PROPOSAL TO DESIGN AND FABRICATE
CURSOR GENERATING CIRCUITRY (U)

Addendum 4 to
Proposal No. C126-CP65

PROPOSAL TO MODIFY FLIR-3
SYSTEM FOR IMPROVED PERFORMANCE

Proposal No. C126-CP65
Part 6
7 December 1966

FIGURE 3

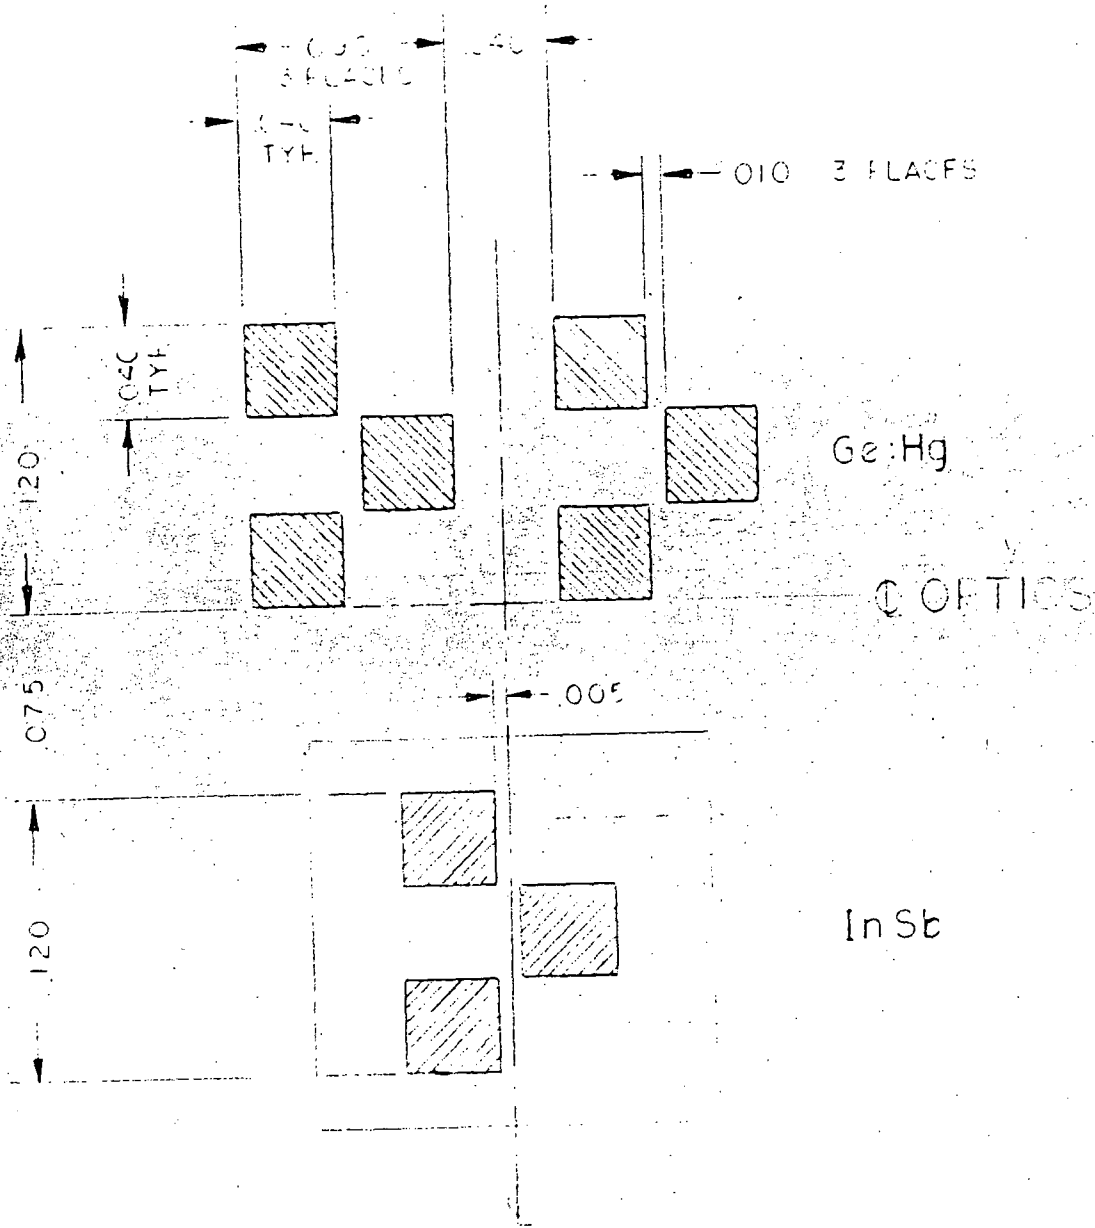
Figure 4 shows the delivery date for the modified system. The modification program started with a detector configured as shown in Figure 3. This detector orientation was dictated because InSb arrays were fabricated and design time for the base was minimum. However, this detector does not superimpose video from both spectrums. The InSb video is displaced down and to the left. Intense targets (hot or cold) would have "ghosts" of varying intensity depending upon the Video Selector knob setting. Since the cursors are triggered from the middle channel of the Ge:Hg sweep, a target appearing on the InSb sweep would be displaced 10 mr from true location as defined by the horizontal cursor. Stores drop could be accomplished with Ge:Hg video only.
